SUBJECT: Contract No. DE-AC24-03OH20152  
Contract Deliverable 039 – PRS Documents  
**CONTINGENT REMOVAL ACTIONS FOR CONTAMINATED SOILS -  
ADDENDUM 1: STRUCTURES, PUBLIC REVIEW DRAFT**

### Addendum 1: Structures

### Action Memorandum for Contingent Removal Action for Contaminated Soil

SUBJECT: A) Action Memo – Engineering Evaluation/Cost Analysis “Contingent Removal Action for Contaminated Soil” September, 2001 Public Review Draft Listing PRS 421 and 5 Others

Contingent Removal Action - Process for Newly Discovered Sites or To Add Existing PRSs

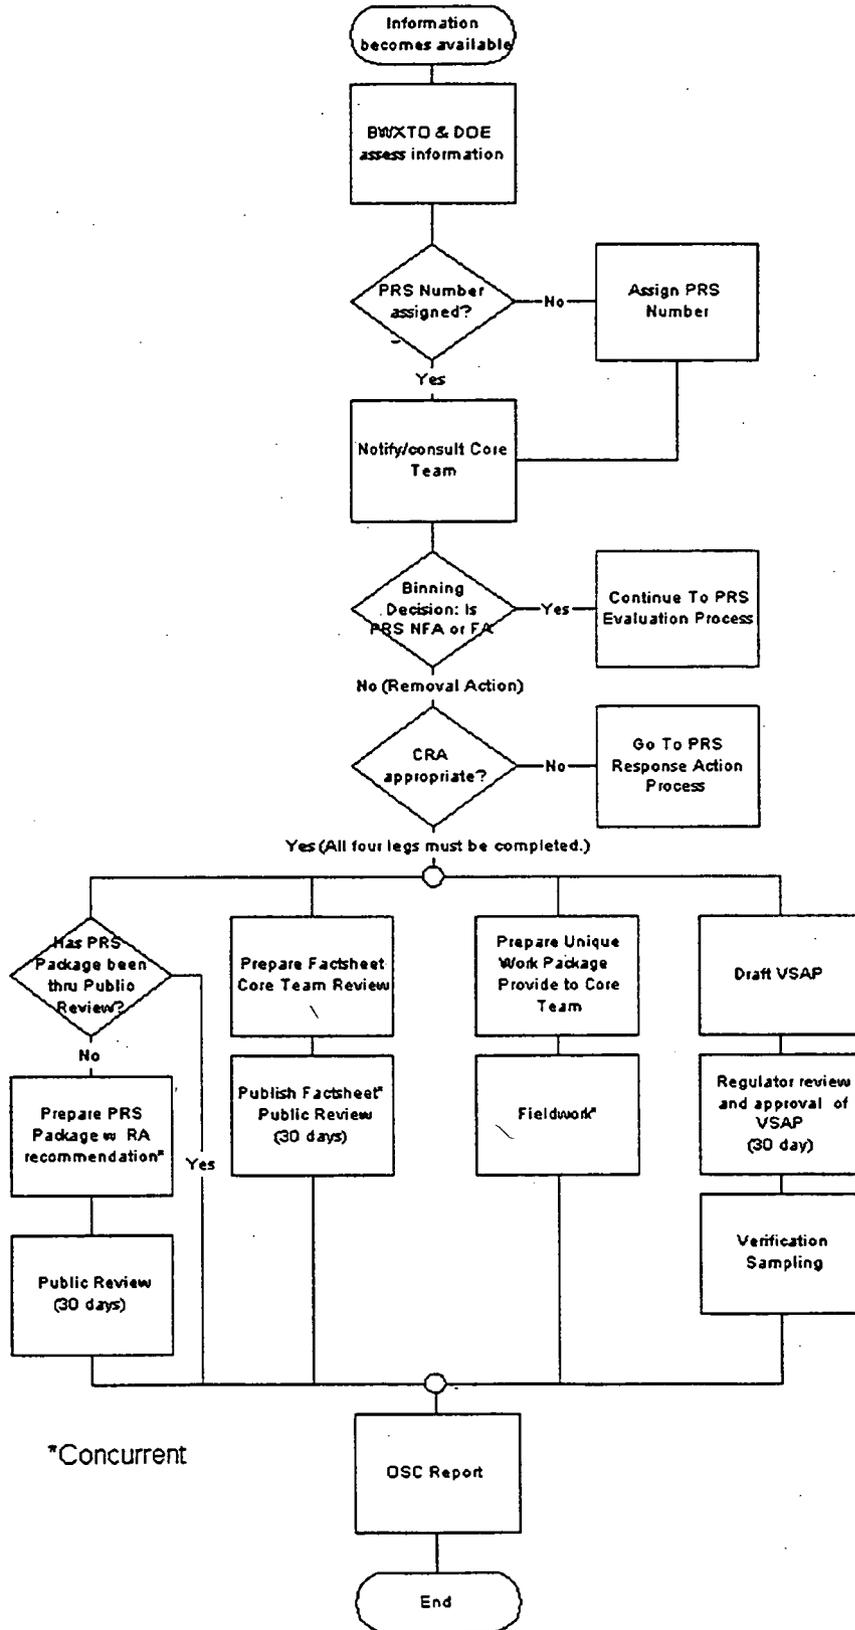
1. MMCIC concurs that a removal action is warranted for the areas identified as PRS 153, 266, 273, 276, 412, and 421, and that the combined AM/EE/CA for these areas, described in the above-referenced document, is an efficient approach that still meets the requirements of the CERCLA/Mound 2000 process. However, MMCIC is unclear how newly discovered cleanup areas will be addressed in the future. Will any newly discovered areas first become a PRS and go through the binning process for removal, or will these designated sites go directly for removal action in accordance with the guidelines in this action memorandum? MMCIC intends to ask for a briefing with DOE and BWXTO, with Mr. Jim Bonfiglio of MESH in attendance, to clarify this process.

When information that indicates possible contamination becomes available, it is assessed by the site and regulators. In the past, this has resulted in the identification of new PRSs. If the information indicated that this new PRS is similar to those identified in this AM/EE/CA, then removal action in accordance with the guidelines in this AM/EE/CA is warranted.

The briefing mentioned above took place on November 7. As a result of that discussion, a flowchart of the process for newly discovered sites was developed and is included in these responses.
